Town of Parker Community Development Department
 Development Review Division
 Attention: **Stacey Nerger**

Application Type: **Minor Development Plat**
 Status: **First Referral**
 Application Name: **Lincoln Professional Park Filing No. 1 MDP**
 Case/AP#: **SUB20-002**
 Referral Received: September 22, 2021
 Comments Due: October 20, 2021

Review date: **October 14, 2021**
 Plan reviewer: **Randall L. Capra, rcapra@parkeronline.org**
 Phone: 303.805.3163

TOWN OF PARKER	FIRE/LIFE SAFETY DIVISION:	R REVIEWED FOR CODE COMPLIANCE; REVISIONS REQUIRED
-----------------------	-----------------------------------	---

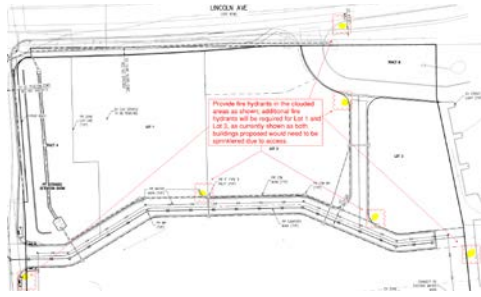
8. **Sheet 3 Overall Utility:** The overall utility drawings are incomplete; the plan set does not address fire hydrant locations for the spine roads proposed. The applicant shall address this issue and fire hydrants will be required in the following locations while noting that additional hydrants will be required on the internal lots depending upon access and use (the gas station will be required to be sprinklered as will Lot 3... as currently shown): *Partially satisfied; the applicant has noted/acknowledged/address with second submittal and has provided all fire hydrants. See location of hydrant beneath yellow highlighted notation below:*

- The entry off of Dransfeldt Road on to Road A
 - The entry off of Lincoln Ave and the current Private Drive
 - Road A (required extension) into Lot 1 Filing No.2 Peaslee Subdivision at Road A and Lot 1

- At the corner of Road B and the Private Drive
- At the corner of Road A and Road B
- At the entry of the gas station off or Road A

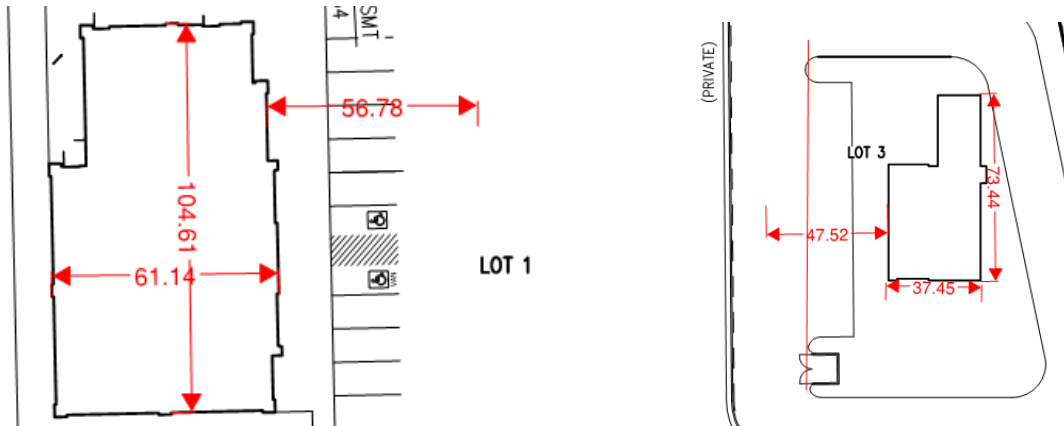
9. The applicant shall be aware that additional fire hydrants (on each individual lot) will be required based upon access, occupancy type, etc. (and certainly based upon what was shown on the submittal documents). This requirement (complying with NFPA 24, section 7.2.3) will be evaluated for each individual lot as applications are submitted though it would be advisable for the applicant to plan accordingly so that cuts into new infrastructure can be avoided.

As noted above, the buildings on Lot 1 and Lot 3 (in the configuration shown) will be required to be sprinklered due to the inability to provide access to all portions of the building (as measured by an approved route by the “fire code official”. Per [18 IFC 503.1.1 Buildings and Facilities], the code does allow the distance to be increased when the building is fully sprinklered. This issue shall be addressed when resubmitting. *NOTE - The location of the riser rooms must be approved; the required fire hydrants for each of the condominium buildings. Satisfied; the applicant has noted/acknowledged/address with second submittal.*
